The Great Grid Upgrade

Norwich to Tilbury

Environmental Implications of Change – Suffolk 1a

AENC-ARC-CNS-REP-0002

Image 1: Proposed Change

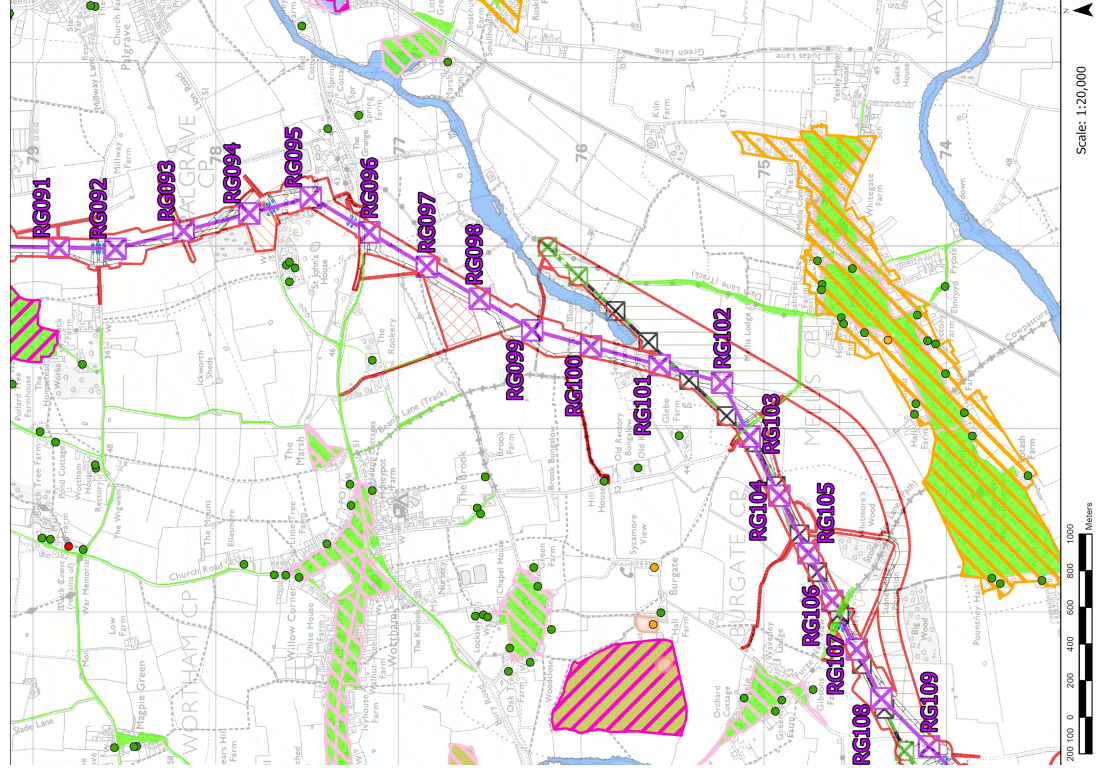
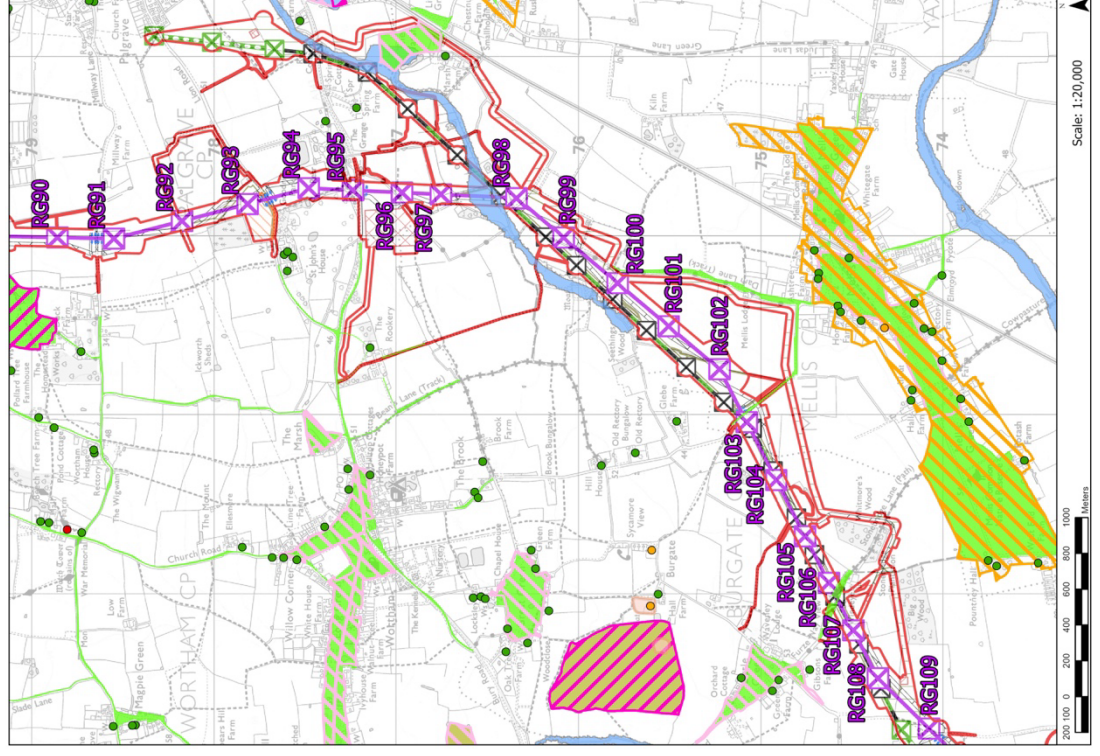
1.1.2 Image 1 presents the Statutory Consultation design and the proposed change together with key environmental constraints using the key below.

We've extended the area shown on this map (proposed area of change) to the south to show where we are proposing to remove some existing 132kV pylons and replace them with underground cables (as annotated). This revision does not affect the information presented in the Suffolk 1 leaflet or the accompanying EIC document as those materials were based on the area now shown.
